Wildlife Encounters 270 Beauty Hill Road Tax Map 249 Lot 32 Tax Map 250 Lot 133

FES #1808

Farwell Engineering Services, LLC (FES) is pleased to submit this letter and revised plans on behalf of Mr. Derek Small of <u>Wildlife Encounters, LLC</u> located at the above noted address. This is in response to plan review letter by DuBois and King dated October 2, 2019.

SILT FENCE DETAIL

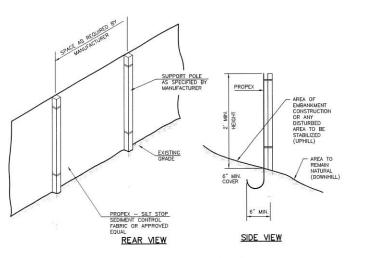
6. Sheet C-2. We recommend that the applicant revise the plan to show all proposed temporary erosion protection measures during construction (silt fence, hay bales, etc.) on the plan and their associated details,0 in accordance with Site Plan Review Regulations 3.5.3.

Response: The review engineer did not have the complete plan set as this was intended to review the drainage only. The silt fence and silt sock detail is on details sheet D-1, and shown on the site plan.

GRAVEL DRIVE DETAIL NOT TO SCALE

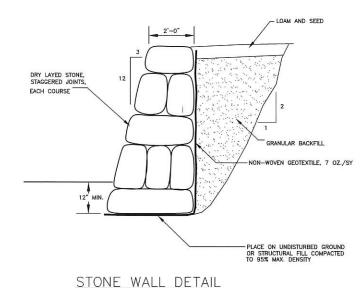
12. Sheet D-2. Details. We recommend that the applicant provide a typical section for the driveway.

Response: There is a typical section shown the profile sheet.

OUTLET STRUCTURE #1

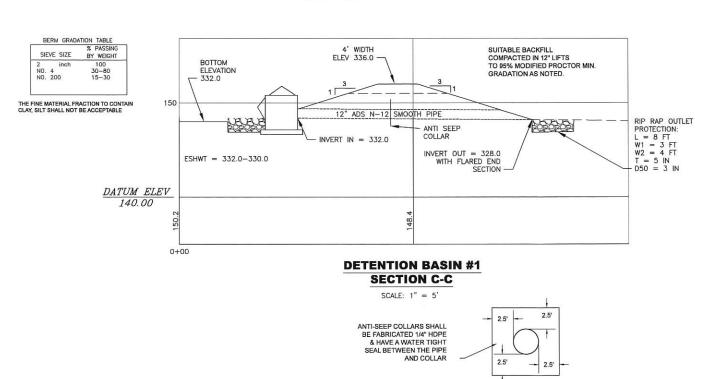
11. Sheet D-2. Details. Outlet Control Structure No. 1 Detail. We recommend that the applicant provide stone bedding wrapped in geotextile for the base of the outlet control structure.

Response: We have added a bedding detail note for the outlet control structure on Sheet D-3.
